ZE1

REV: E2C

PROJECT : ZE1
Quanta Computer Inc

Dothan Processor

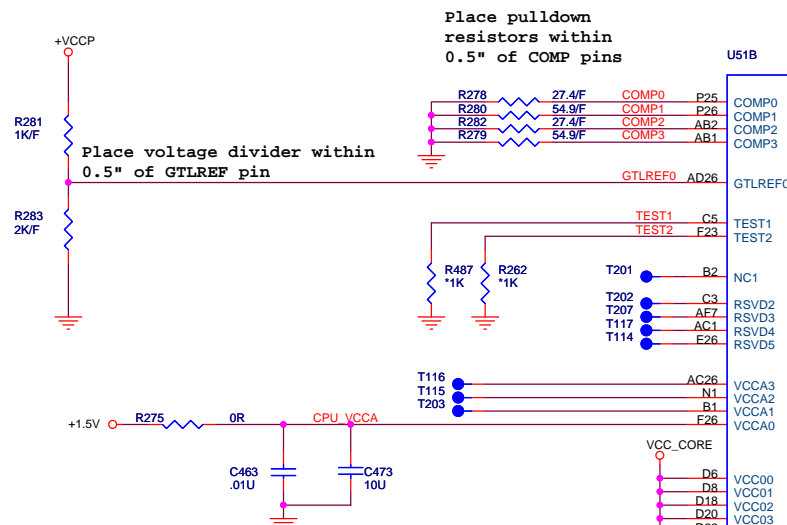
ECN C2A

IDE_LED#

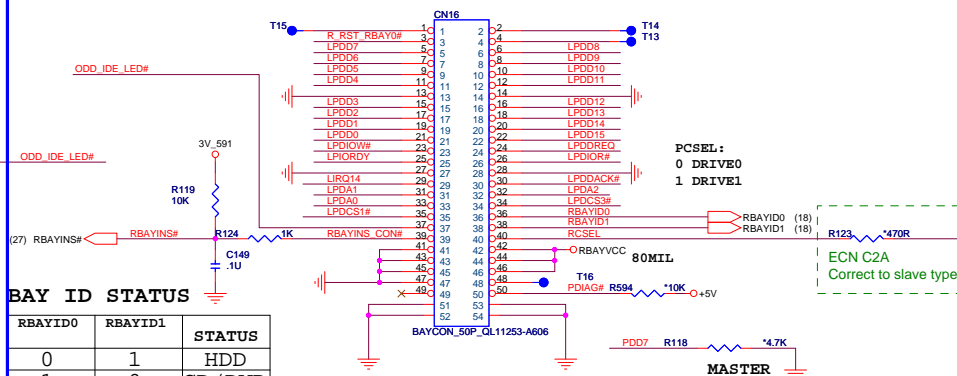
EN C2A
Need change to Green color

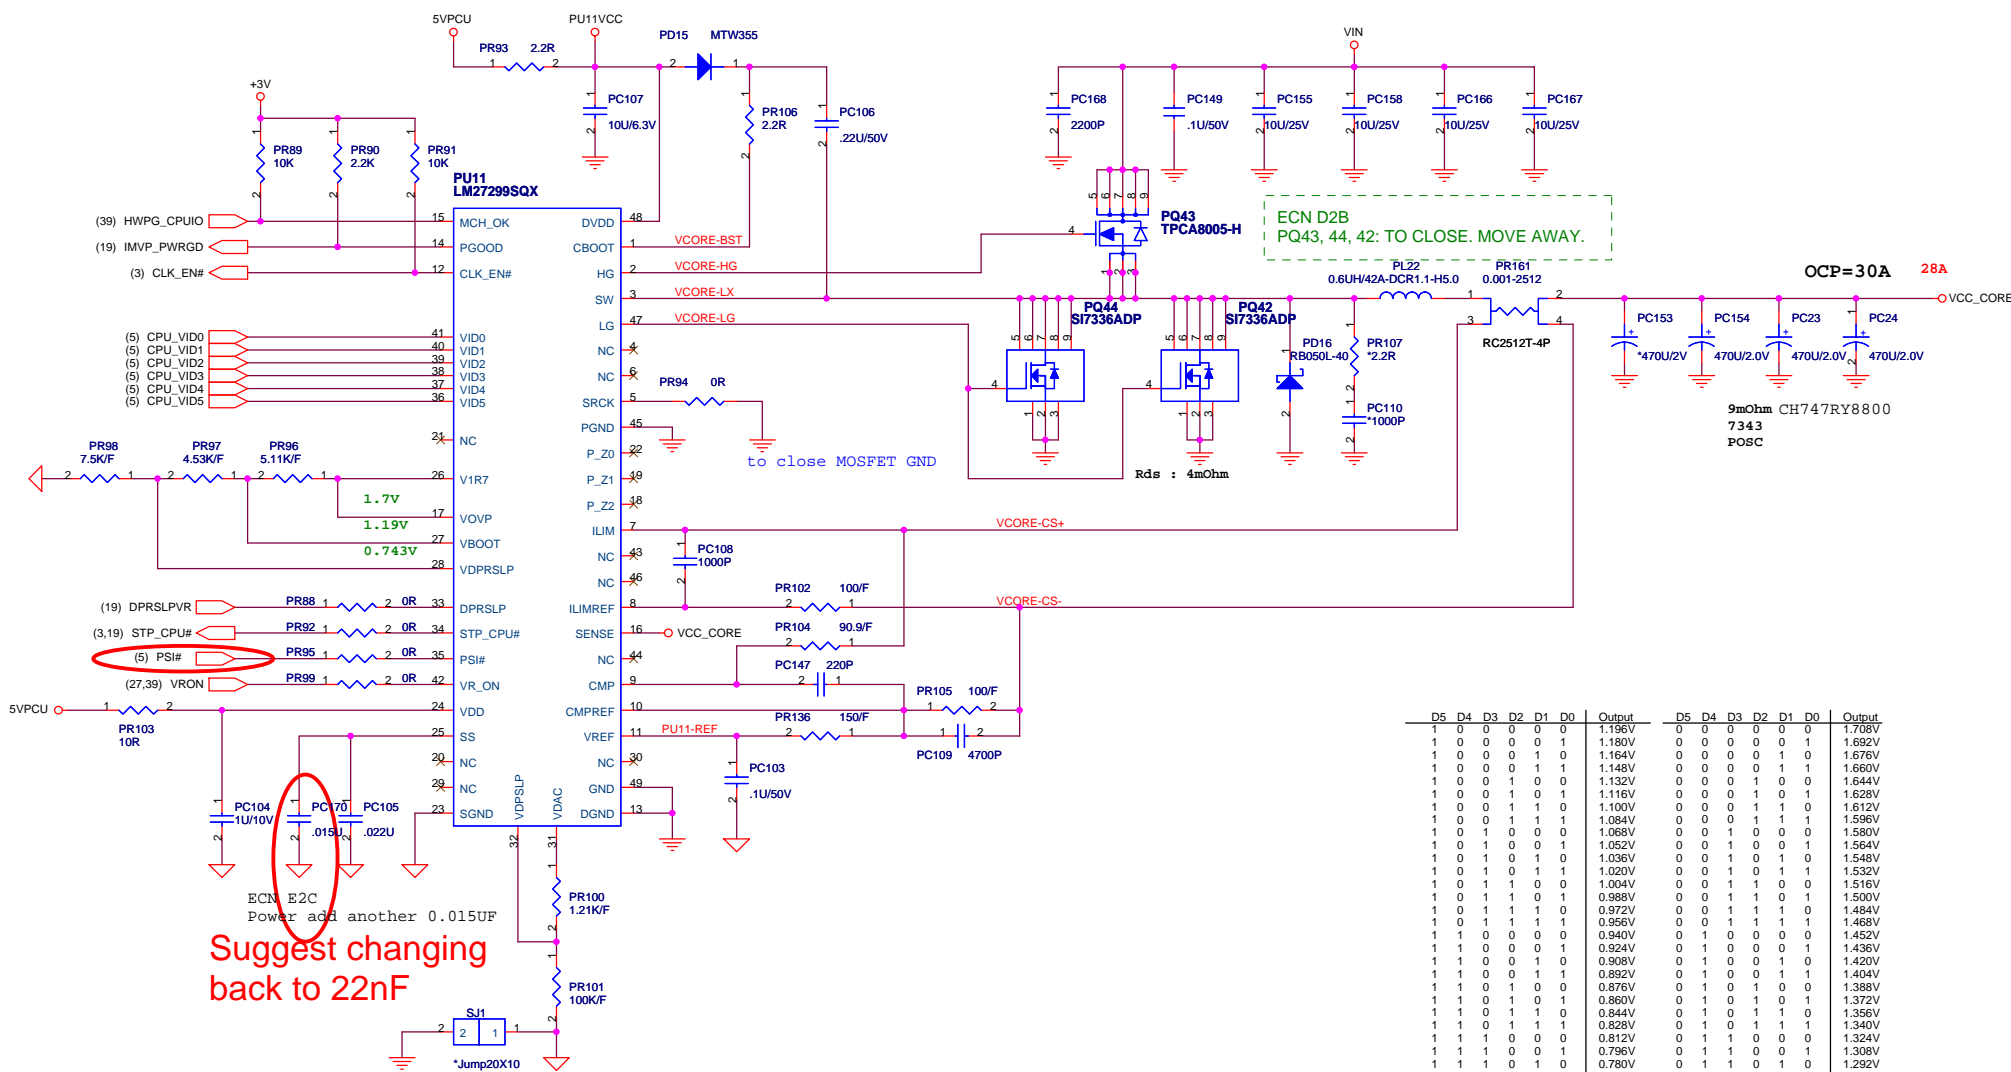
Suggest changing
back to 22nF

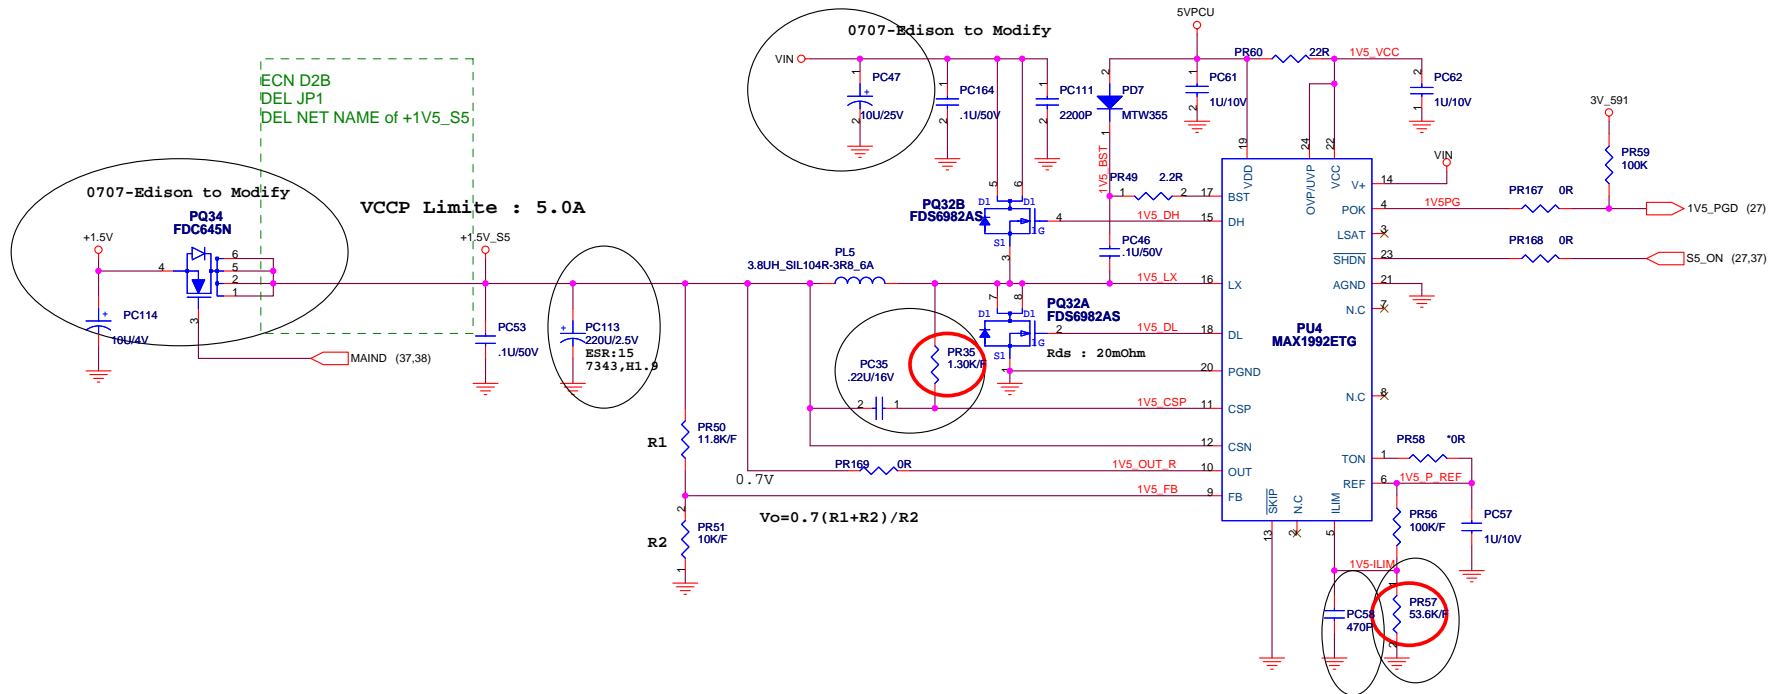
ECN D2B
ME/ PWR
UPDATE CN21

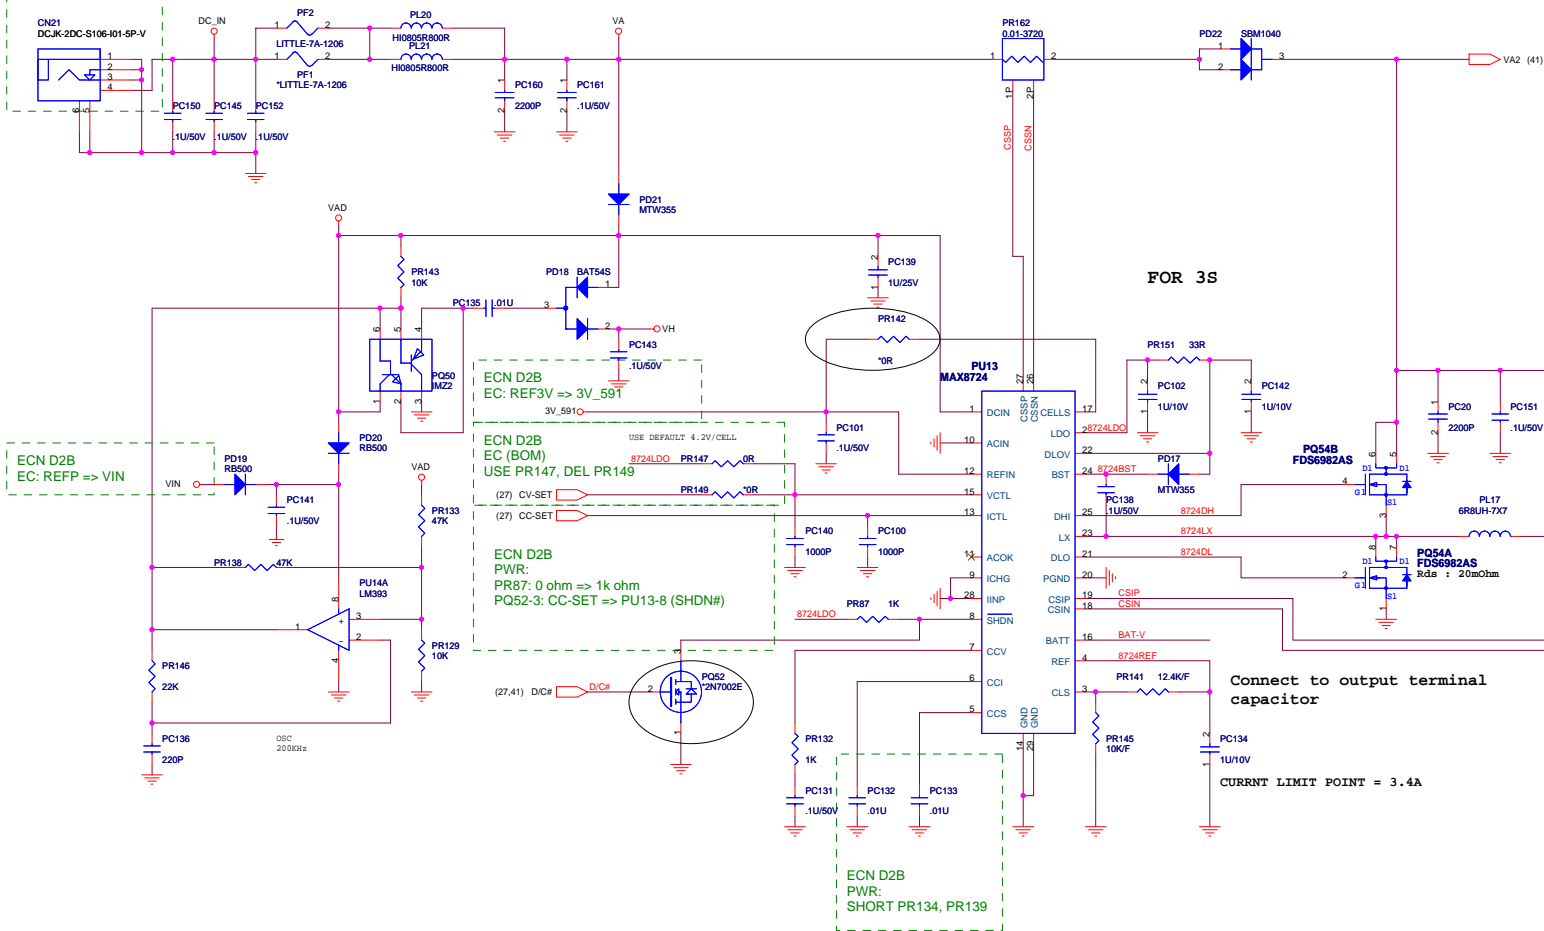
ECN D2B
EC: REF3V => 3V_591
EC: REFP => VIN
DEL PQ41, PU10, PC97, PC98, PC99
